COMMUNITY & ECONOMIC DEVELOPMENT OFFICE

RE: Summary of Questions and Responses for City of Burlington RFP for Site Work Construction Bids for City Hall Park Kiosk

1 KIOSK COLUMN FOOTING

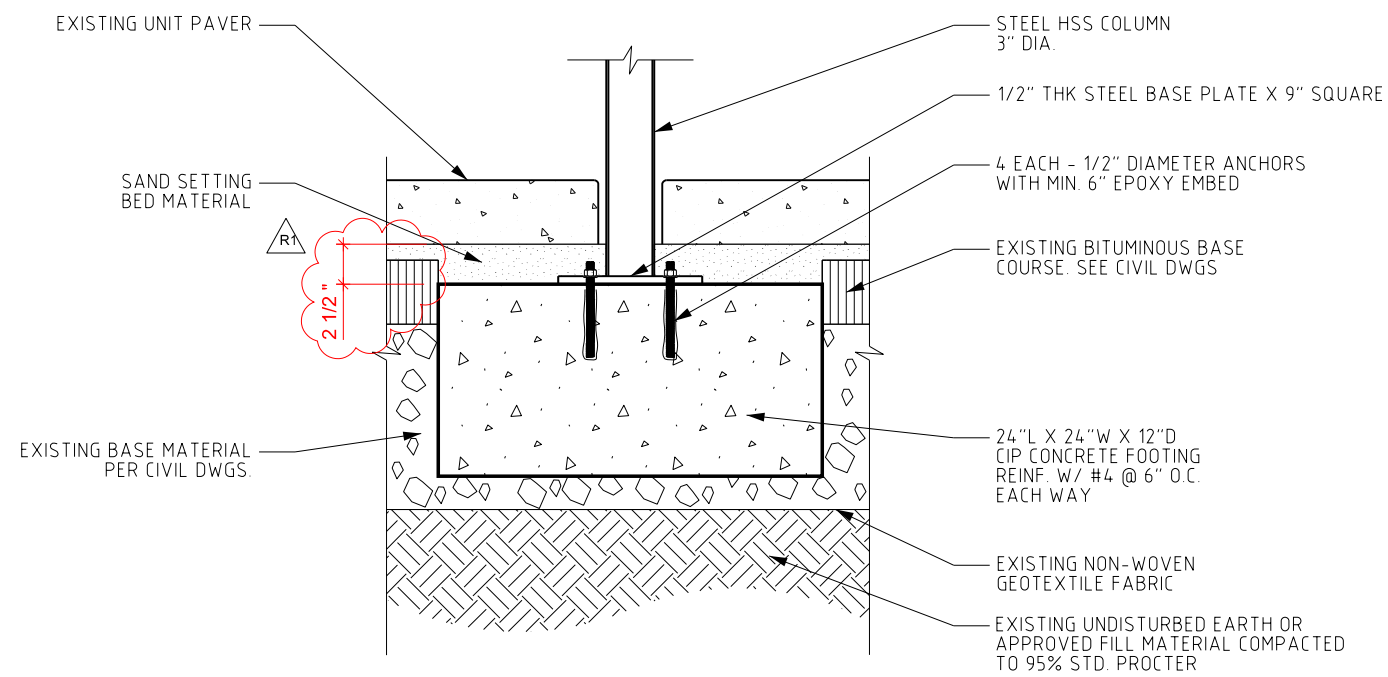
Question 10-1: Grading plan? Top of concrete footing for (2) piers?

Response 10-1: See attached sketch on Sheet A-022.0, Detail 1: Kiosk Column Footing.

2 KIOSK PAD

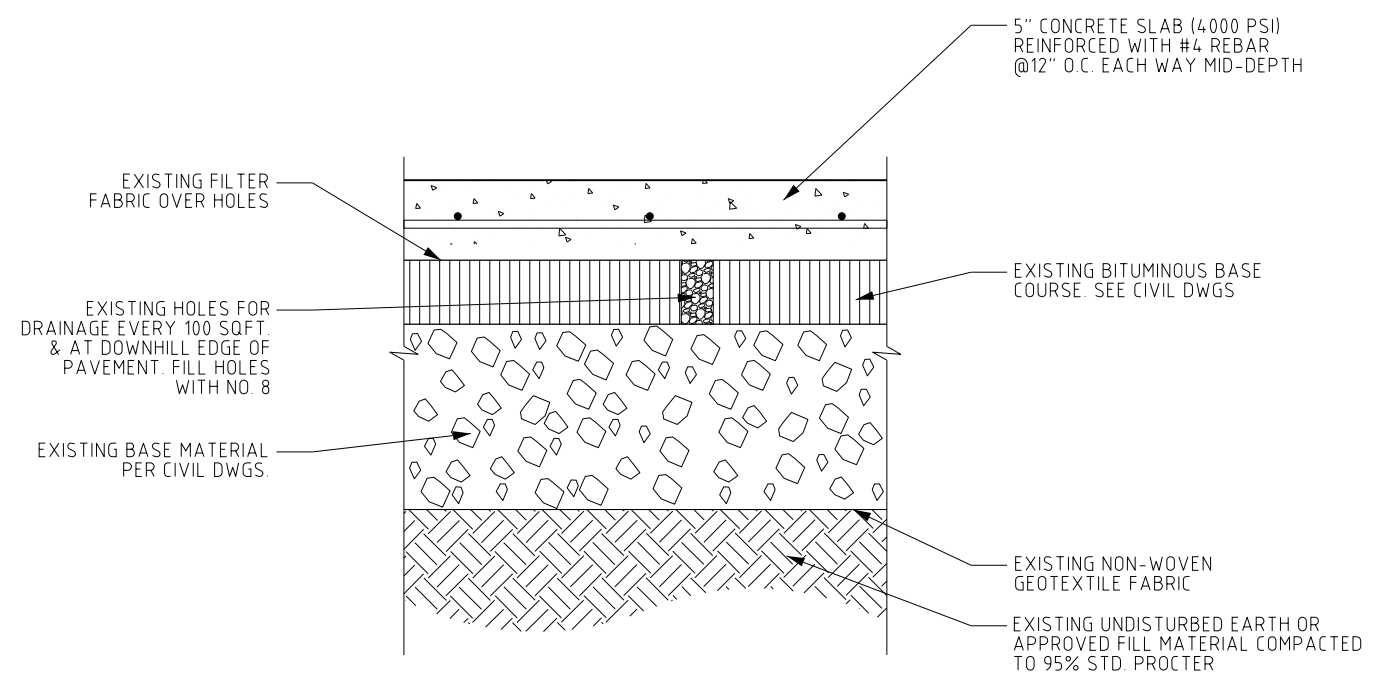
Question 10-2: Top of concrete slab for kiosk?

Response 10-2: Top of concrete slab to match adjacent pavers elevation.
